TO: Mayor Trey King, City of Dacula
ATTN TO: Brittini Nix, Director Planning and Economic Development, City of Dacula
RE: Development of Regional Impact Review
FROM: Mike Alexander, Director, ARC Center for Livable Communities

Name of Proposal: Allora Dacula DRI 3750

Description: A DRI review of a proposal to construct a mixed-use development with 378 multifamily units, 233 townhouse units, and 473,200 square feet of industrial space on a 103 acre mostly wooded site off of Stanley Road in the City of Dacula in Gwinnett County.

DRI SITE PLAN

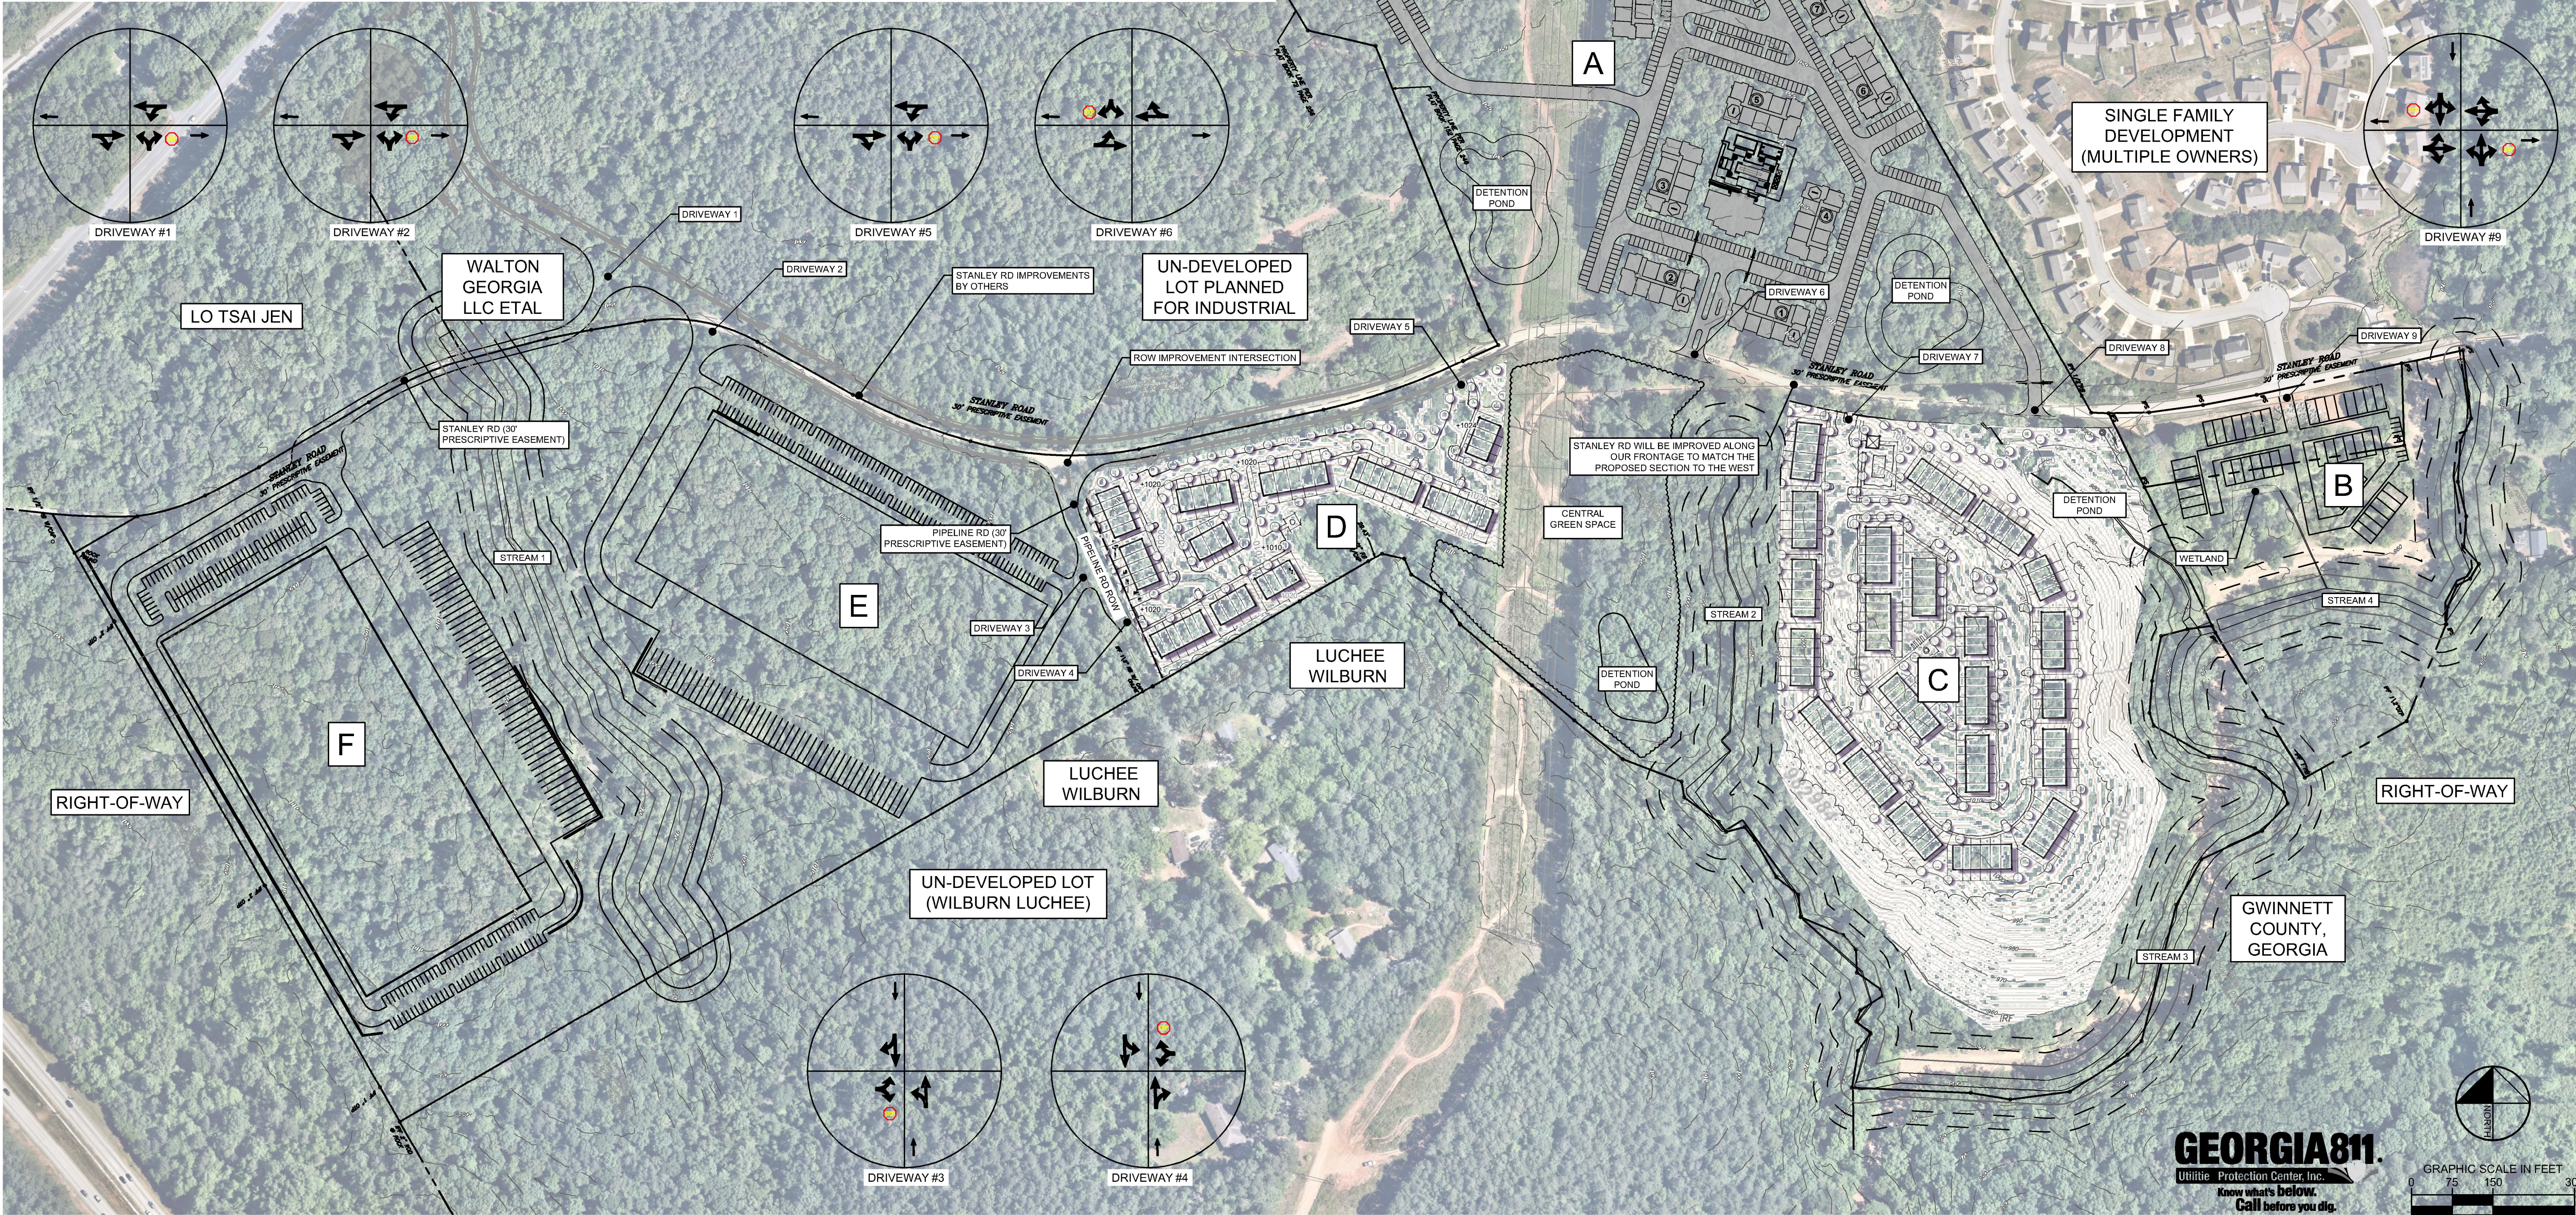
Incorporation of green stormwater and heat island mitigation designs for the roughly 1,102 surface car parking spaces proposed would be supportive of regional environmental policies.

The TIS notes that pedestrian facilities will be provided throughout the development but the location of these facilities is not apparent on the site plan; because of the size of the development, a hierarchy of pedestrian amenities, including a wider multi-use path connecting Parcels A, B, C, and D, with standard sidewalks within each Parcel, would support regional multi-modal transportation goals.

The TIS notes that pedestrian facilities will be provided throughout the development but the location of these facilities is not apparent on the site plan; because of the size of the development, a hierarchy of pedestrian amenities, including a wider multi-use path connecting Parcels A, B, C, and D, with standard sidewalks within each Parcel, would support regional multi-modal transportation goals.

Much of the existing site is wooded; additional retention of existing trees on the site would be desirable and in keeping with regional goals regarding carbon sequestration, water quality protection, and climate change/heat island effect mitigation. A portion of the site is shown as open space and water quality protection buffer areas. Designation of this area as managed open/conservation space could meaningfully reduce the overall impact of the project. There may be potential opportunities for linking these fragmented undeveloped areas with adjacent undeveloped or protected areas to ensure their maintenance and potential use for recreation or habitat preservation.

Incorporation of green stormwater and heat island mitigation designs for the approximately 1,102 car and surface parking spaces would be supportive of regional environmental policies.
